End of STC Building M Office and Workspace Renovation Addendum #1

PROJECT NAME
PECAN CAMPUS BLDG OFFICE & WORK SPACE RENOV. PROJECT #19-20-1010

SHEET NUMBER
ADD. 1-1

Detail D2 Room Finish Schedule

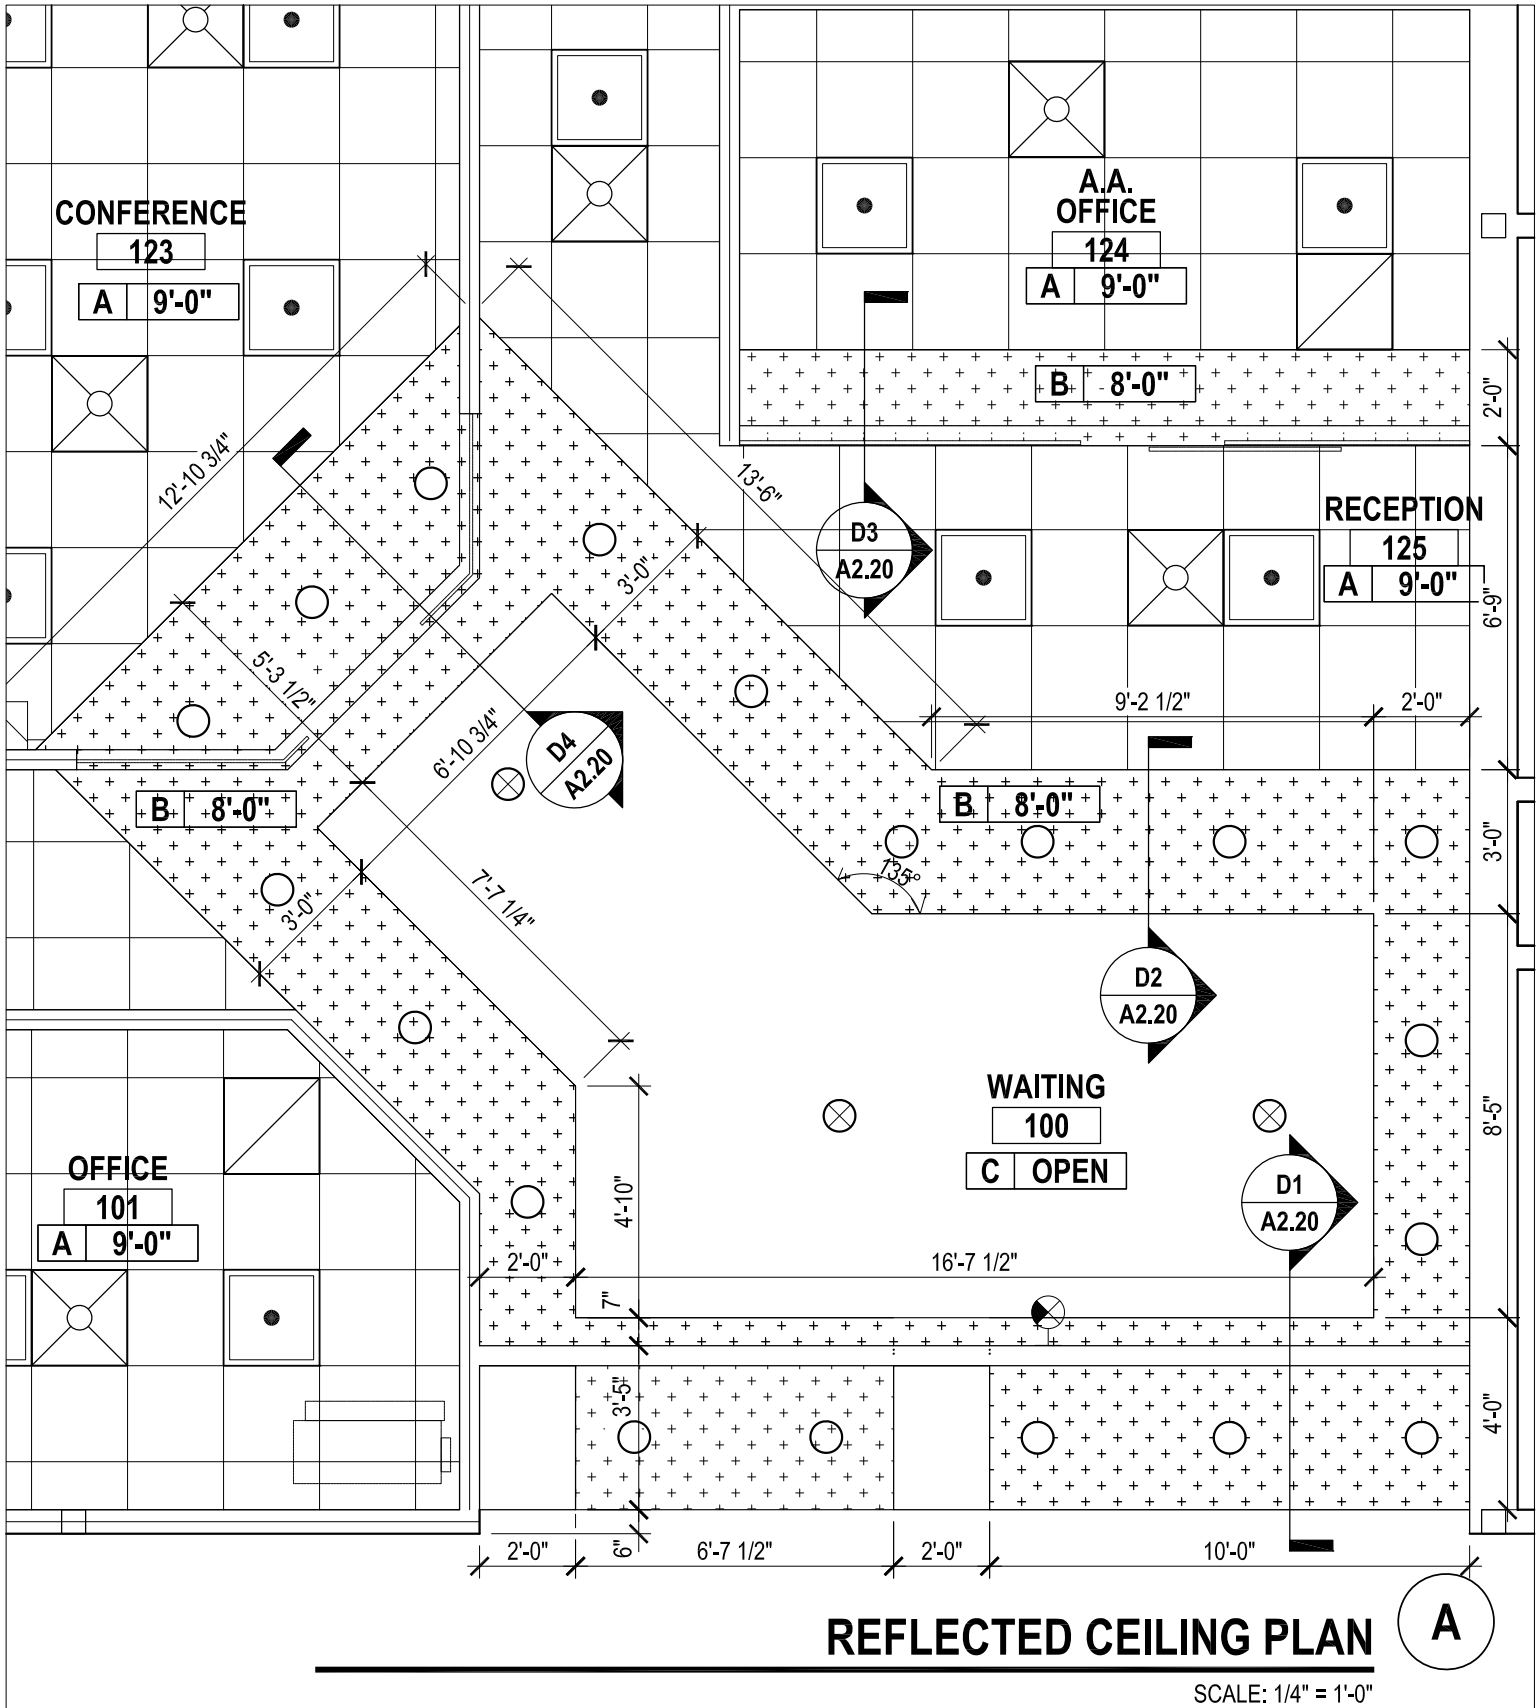
-Delete CTR-2
